HASTINGS HERITAGE PRESERVATION COMMISSION

Agenda for Meeting of May 21, 2024

III. Certificate of Approval Review

ChoiceTrim™ by Royal

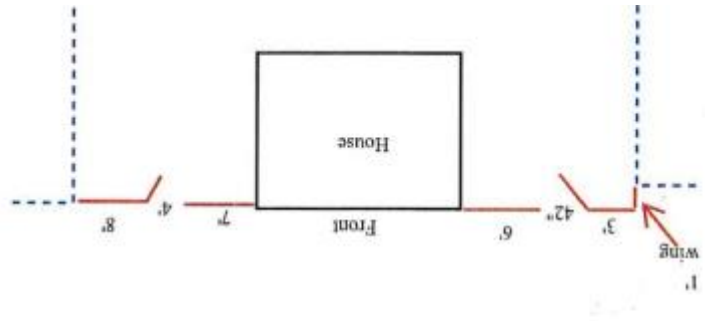
The applicant is also proposing to replace deteriorated garage door wood trim with similar PVC trim.

The existing trim to be replaced is not historic, damaged, and not visible from the street. The proposed trim is a different material but has a similar design.

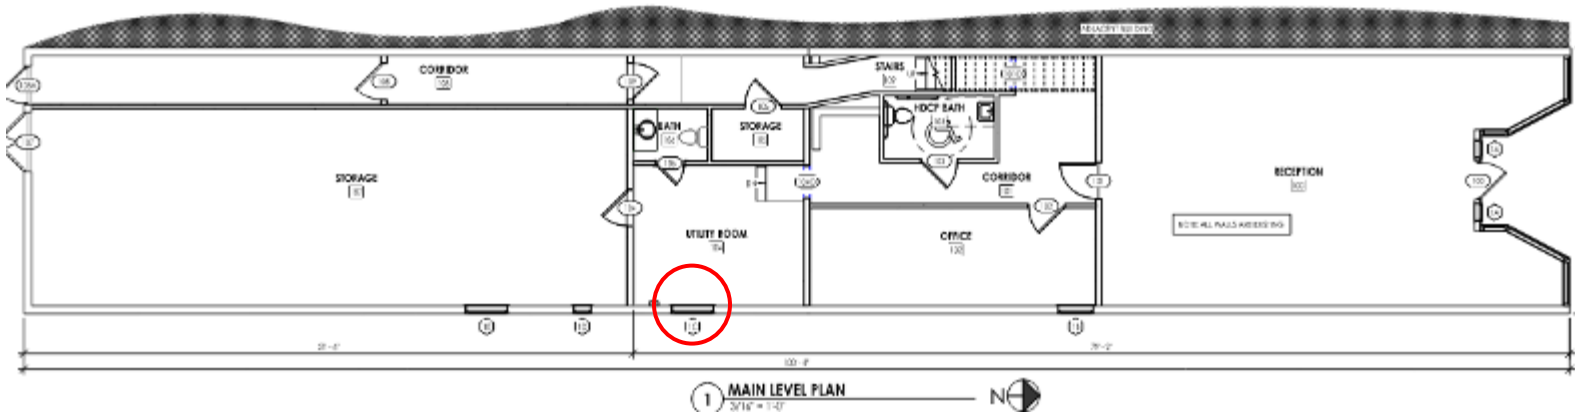
The Design Guidelines state that new entry openings should not be introduced to principal elevations. There isn't a definition of principle elevation in the Design Guidelines, but the word principal has historically been singular. This is a visible elevation facing Ramsey Street, but not directly fronting it, and it is not more prominent than the front of the building.

The Design Guidelines state that historic windows should be maintained, not enlarged, or filled in. This building addition (or at least this portion of the wall) seems to have come after the 1924 Sanborn Fire Insurance Map publication. While it could still be considered historic, it is not nearly as old as the original building. The actual date of construction is unknown.

The proposal is at odds with several Design Guidelines if the window and wall had historical integrity. They may have historical integrity if they were constructed soon after 1924.

Citrus (1122)

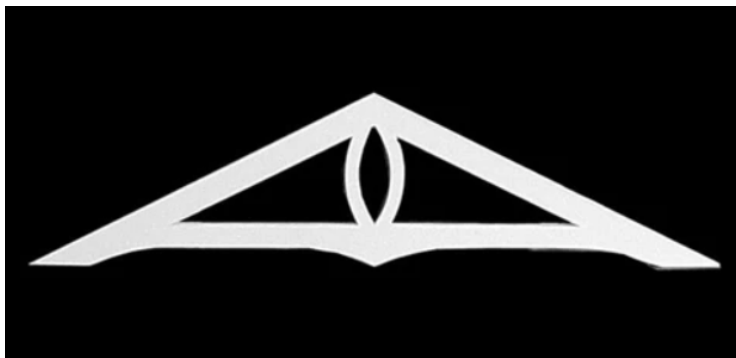
- b. Square wooden posts were used on similar houses in the area. They may have been turned or plain. The proposed posts seem appropriate.
- c. Architectural details are supposed to resemble the original design. Unless a historic photograph can be located, the original design is unknown. There are houses like this in Hasting that have and don't have these brackets on the porch and gables. If there was a bracket on the gable, there would likely be proof on the fascia board if original. The same would go for the porch had it been the original. There is no documentation of what the porch posts, spindles, and floor looked like, but it obviously had them so we can use the architectural style and era to make an educated guess on their appearance. However, not all houses had bracketry.

- b. We would like to add small wooden brackets to the porch and a small gable piece at the second floor window. Folk Victorians were known for the simple structures of the homes and their small, ornate, decorative touches on the porches and gables. We would like to incorporate these appropriately and paint them the accent color of burgundy.
